SERVICE BULLETIN #1105

SUBJECT **PROTECTIVE PARTS ADDED TO PLUNGE BOW KIT**

MODEL **1-61**, 1-60, 1-81, 1-80 DATE 9/16/60

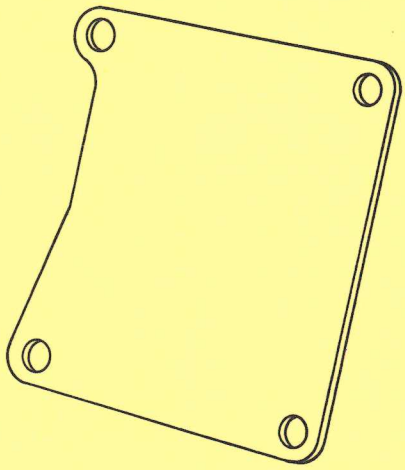
To protect the crankcase bottom and the fuel tank assembly of the above listed chain saws, two new parts have been added to the Plunge Bow Kit, P/N 55152:

P/N 57494
Chain Guard

P/N 57530
Crankcase Cover Plate

The Chain Guard, P/N 57494, replaces the earlier chain guard, P/N 51889, when the Plunge Bow Kit is installed on Model 1-61 and 1-60 engines only. When the Plunge Bow Kit is installed on Model 1-81 or 1-80 engines, use the earlier 51889 chain guard in place of the new 57494 chain guard.

The new Crankcase Cover Plate, P/N 57530, is used with the Plunge Bow Kit on all 1-81, 1-80, 1-61, and 1-60 engines. It should be mounted on the crankcase bottom cover using the four crankcase bottom cover screws.
